Review Committee Report

Conceptual Design

**Capture Cavity 1
Modifications**

Sep 2012

FIGURE 1.1 Capture Cavity 1 Cross Section

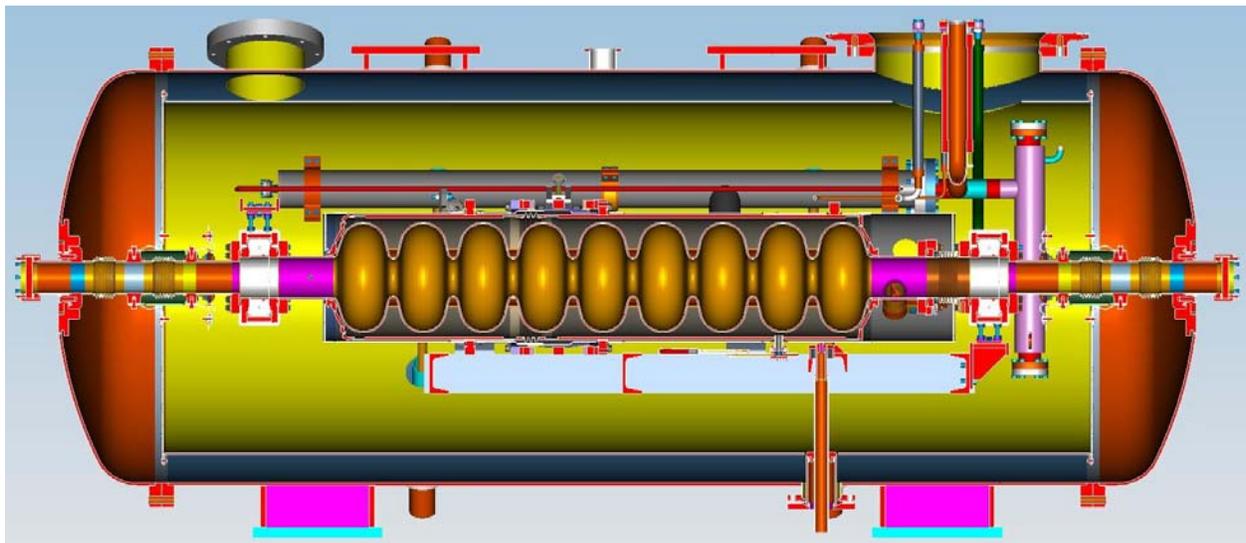
The use of the blade tuner requires about 1 mm of motion at the non-coupler end. The coupler end of the cavity will be anchored to the support frame. The non-coupler end is shown with a pair of needle bearings allowing axial motion of the cavity and two pairs of needle bearings allowing motion of the manual gate valve.

CC-1 utilized a low thermal conductivity vertical pin to anchor the cavity in the beam direction. This same pin will be used in the new design. It will, however, pin into the support frame instead of the cavity directly.

New manual gate valves will be used. They will be closely coupled to the cavity and mounted horizontally which will conveniently allow them to align with two existing ports in the vacuum vessel. External access to the manual valves in the original design was very difficult.

Many of the thermal intercepts will be of a clamped design (either around a cooling pipe or around the load, in the case of the slow tuner motor or HOM couplers.) Other intercepts, such as the support frame, beam pipe intercepts and connections directly to the 80K shield were generally shown as a single bolted tab on the end of a copper braid.
